Powell Amenity Center
212 Perseus St. Lillington, NC

To Whom It Concerns
Attn: Harnett County Environmental
RE: Plan Review Comments

"QPG Kona Coast"

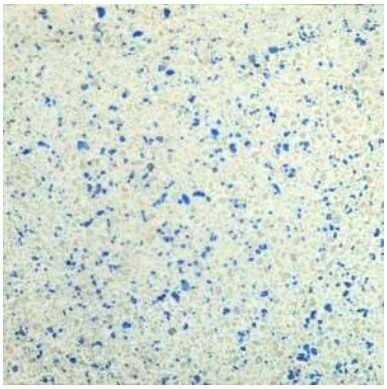
- Comment 3: Specify pool color finish.
  - Pool plaster specification has been added to this document.
- Comment 4: Indicate if flooring in the restrooms is slip resistant: plans specify a smooth finish.

QPG Kona Coast Quartz Pool Plaster
